# NORTH EAST GROWTH CORRIDOR SHEPPARTON

DRAINAGE STRATEGY PEER REVIEW  
13 JULY 2018

PREPARED FOR VICTORIAN PLANNING AUTHORITY

Figure 1: Reeds NEGC Drainage Catchment Plan.

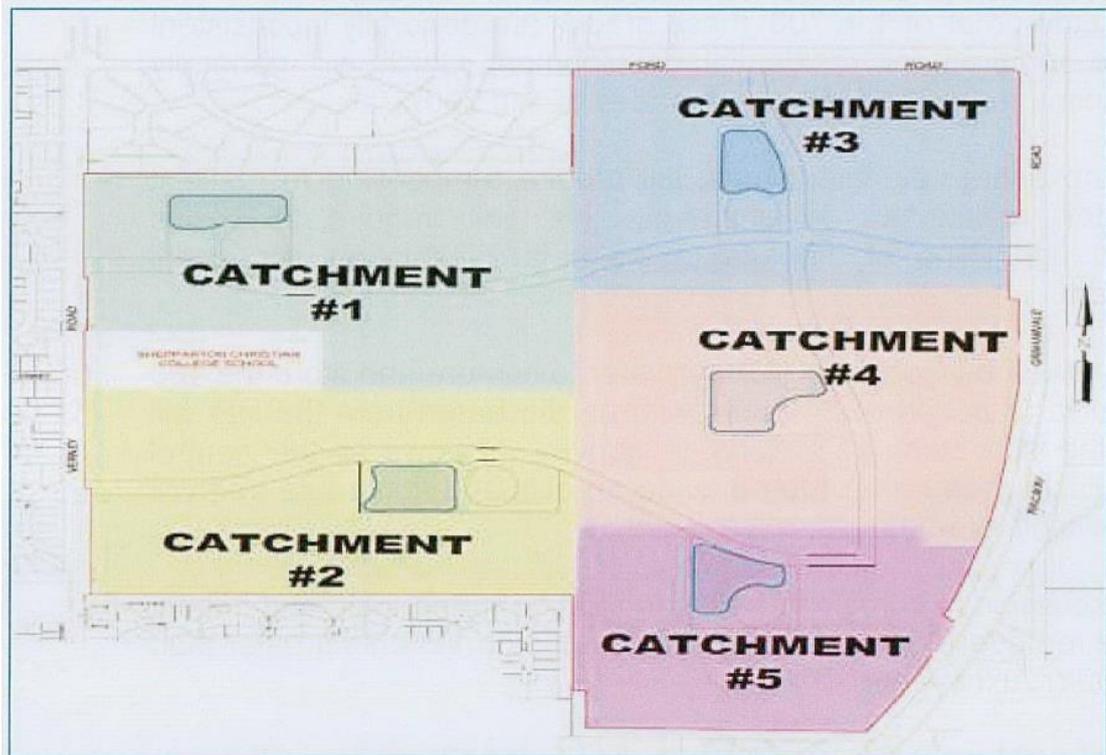
Based on the 5 drainage catchments in Figure 1, Reeds have undertaken a functional design for the basin in catchment 1 as shown in Figure 2. Based on this design Reeds have completed an opinion of probable cost for the construction works to determine a cost that can be apportioned over the remaining catchments.

By reducing the catchments from 5 to 4 it has increased the overall size of catchments 3 and 4 by consolidating catchments 3, 4 and 5 from Figure 1. These catchments were merged because of the relatively flat ground when compared to catchments 1 and 2.

**Figure 2: Reeds Consulting Catchment 1 Functional Design Plan.**

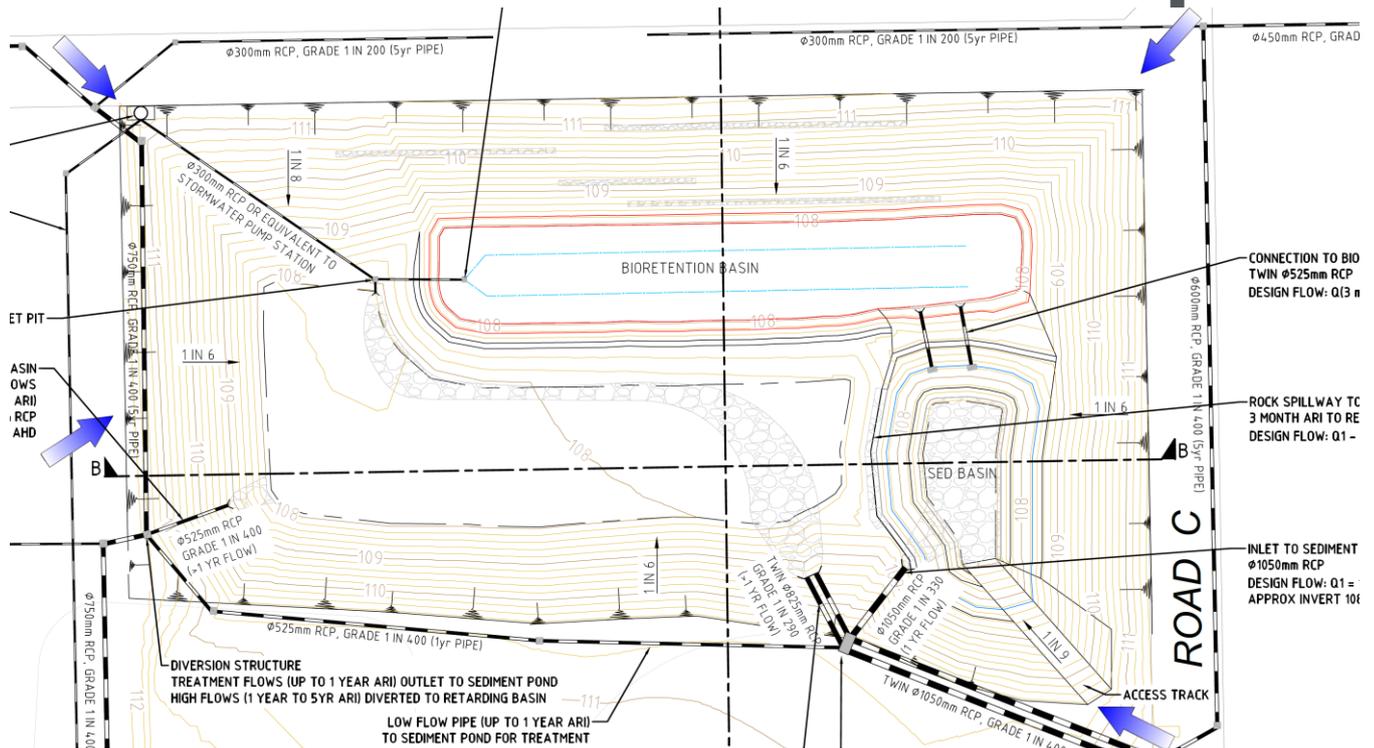
The civil works estimate completed by Reeds in July 2015 estimates the basin 1 civil costs to be \$1,802,568.80. This estimate excludes any construction contingencies, authority fees and charges and any professional fees.

Figure 4: Proposed Basin offset Plan.

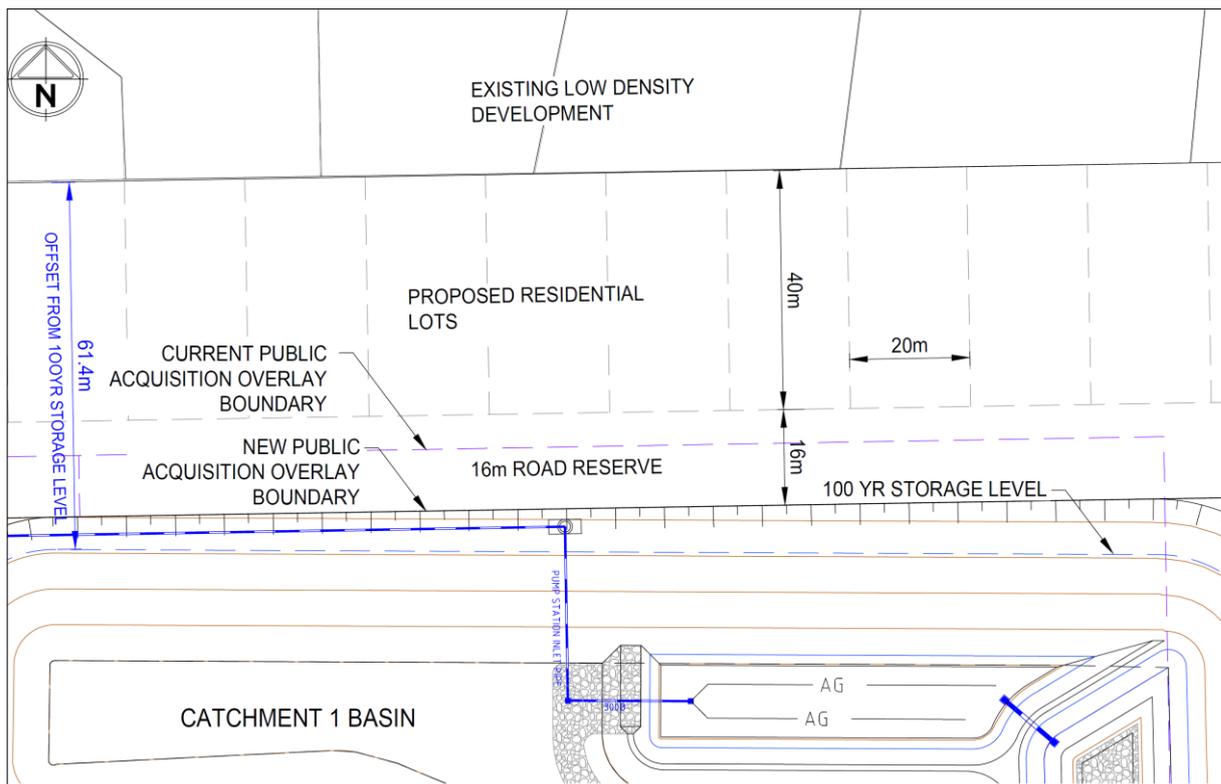
Reeds have located the catchment 1 basin in the North West corner of the catchment to utilise the natural fall of the land. During the exhibition process a submission has been raised in regards to the proximity of the basin in relation to the existing low density residential development north of the basin. The submission relates to concerns over the existing septic systems servicing the existing development and the basin location.

To address this concern Spiire has reviewed the offset and shifted the basin further south as show in Figure 3 below to provide a minimum of 60m setback between the proposed basin and existing septic systems following the guidelines set out in Table 5 from the Environmental Protection Authority (EPA) Code of Practice for Onsite Wastewater Management.

**Basin positioning has been reviewed and shifted further south to provide a minimum setback from the existing septic systems to meet EPA standards. Refer to section 2.2 of the report.**

Figure 10: G-MW Existing Drainage Catchments.

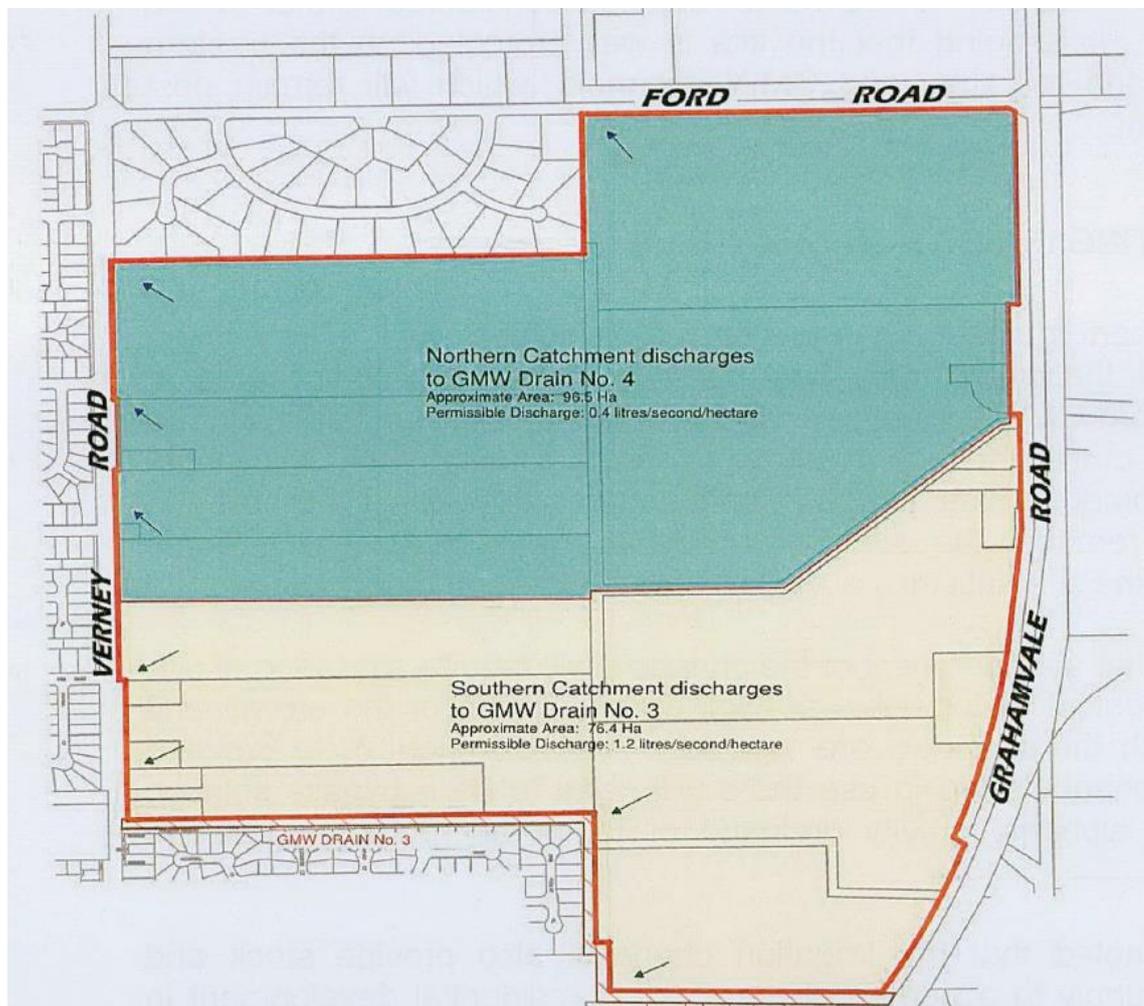
Spiire agrees with Reeds approach to drain all basins rising main back into G-MW's Drain 3 in lieu of draining the northern catchments in G-MW's Drain 4 as shown below in Figure 8.

Figure 11: Spiire's NEGC Drainage Catchment Plan.

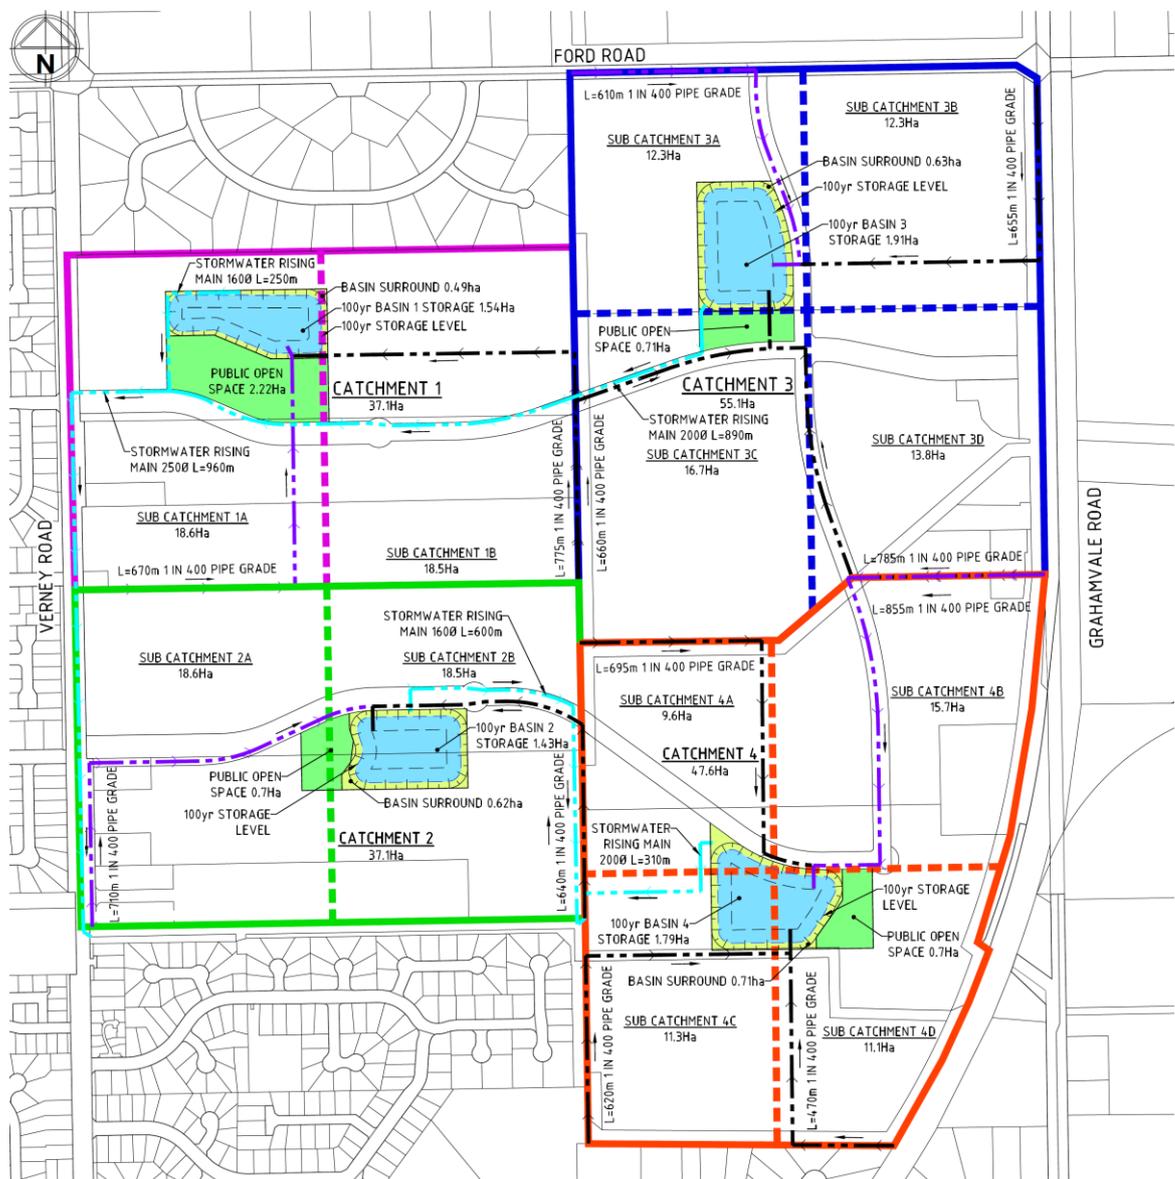
A review of the existing survey information supplied by GSCC shows the natural fall of the land is grading east to west across the site. After analysing the catchments Spiire note the catchment 4 basin is located on an existing G-MW channel where traditionally these assets are located on the high ground to provide irrigation to the adjacent land. A review of the levels confirm this and to reduce earthwork costs to convey 100 year drainage flows to the retention basin, Spiire proposes to split the NEGC into 4 catchments as shown below in Figure 11 and Appendix D.

As shown in Figure 11 catchments 1 and 2 are located on the west side of the corridor and catchments 3 and 4 are located on the eastern side to utilise the available grades.
